Service Bulletin

Bulletin No.: 24-NA-032

Subject: Poor Fitting Charge Port Door and/or Charge Port Door Sticks Out at Bottom

Brand:	Model:	Model Year:		Vehicle Build Date:		Engine:	Transmission:
		from	to	from	to		
Chevrolet	Blazer EV	2024	2025	SOP	April 9, 2025	All	All

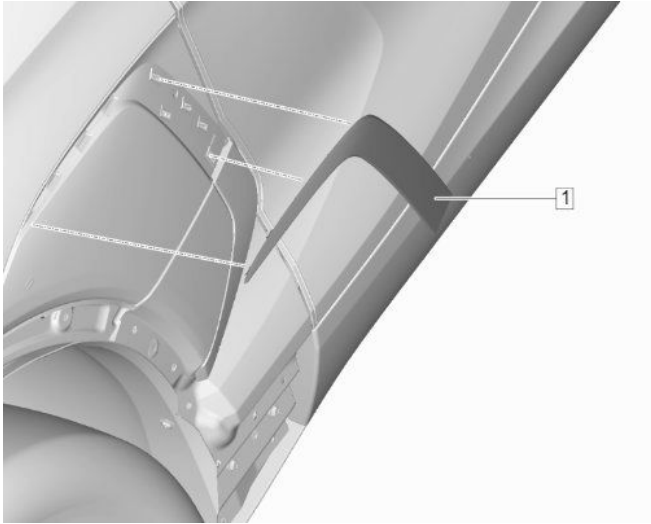
Involved Region or Country	North America
Condition	 <p style="text-align: right; font-size: small;">6550658</p> <p>Some customers may comment on the charge port door not closing all the way and/or the charge port door sticks out at the bottom.</p>
Cause	The cause of the condition may be due to excessive material on the charge port door.
Correction	Refer to the procedure below to remove some of the material so that the door may close fully as intended.

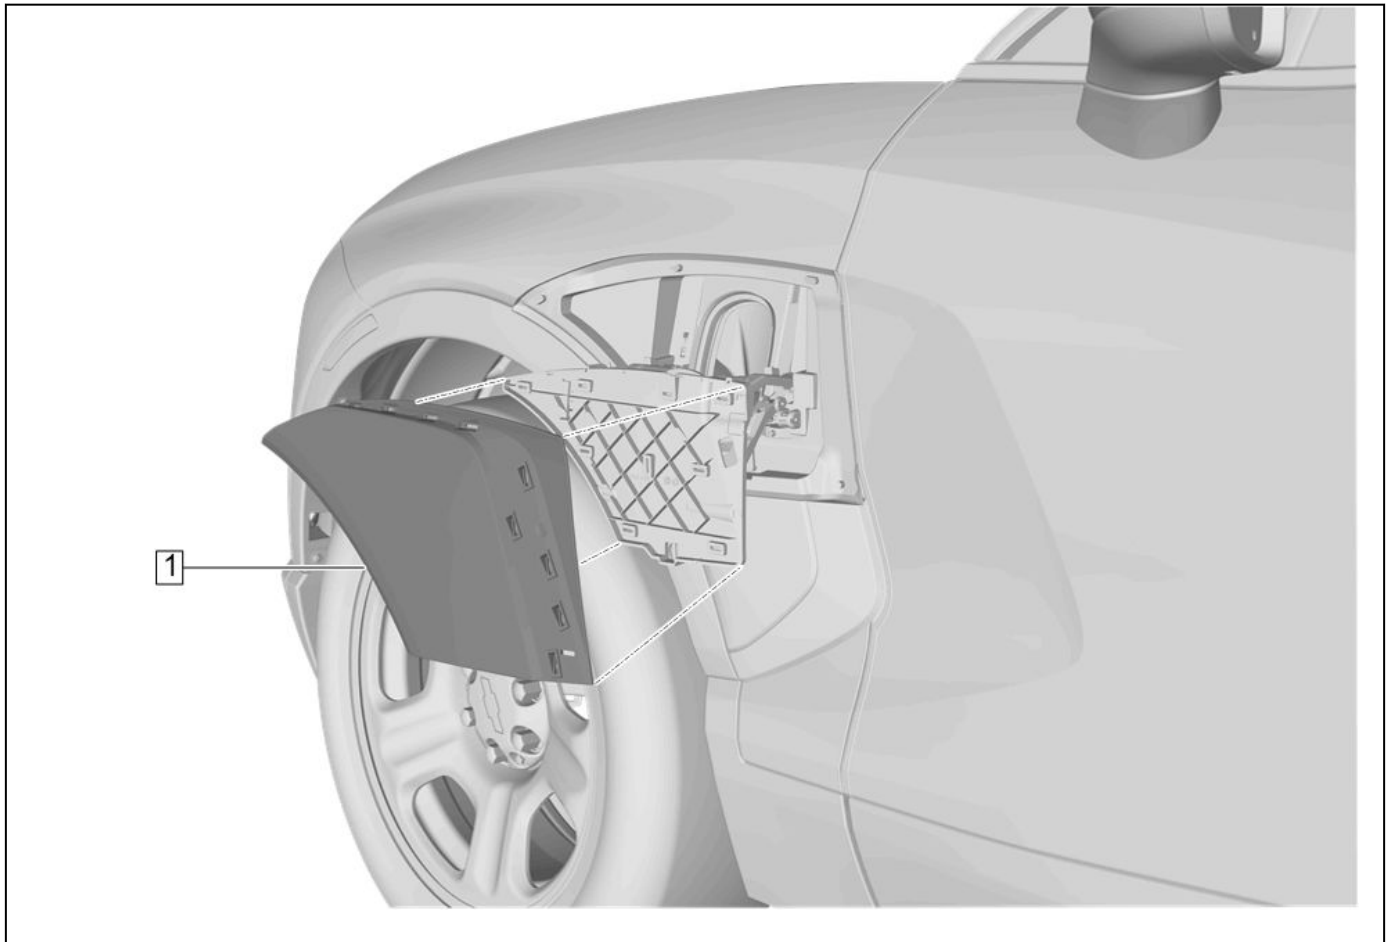
1. Turn the vehicles wheel to the full left position to make it easier to work around the vehicles charge port door.
2. Position the charge port door to the fully open position.

6412960

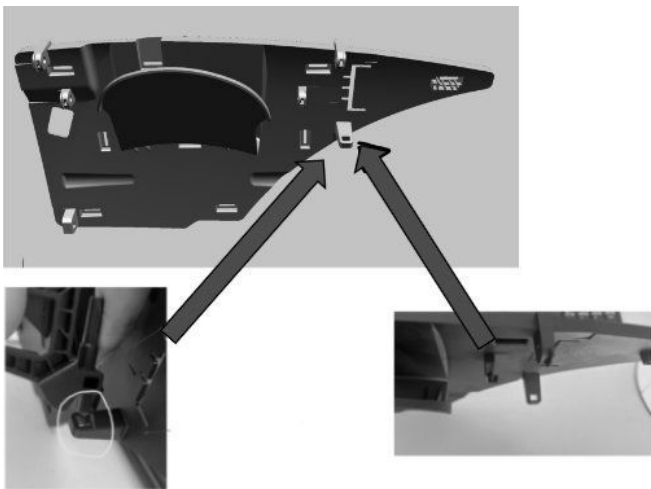
4. Using a trim type tool, release the retainers on the charge port door (1) from the housing.

6550663

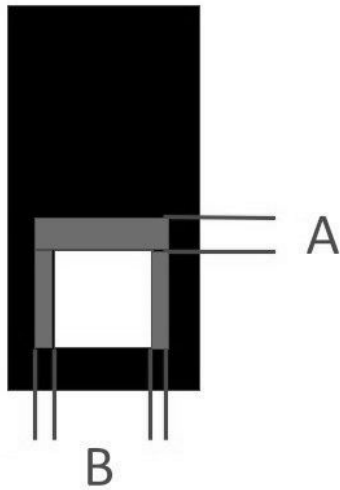
8. While the charge port door is open, use a suitable file, elongate the existing hole shown on the charge port housing. Elongate the hole to the red line.

The illustration above shows the amount of material needed to be removed. 1.6 mm on the side illustrated with the (A) , and 0.25 mm from the two sides (B). The final measurements should be 6.81 mm by 6.6 mm.
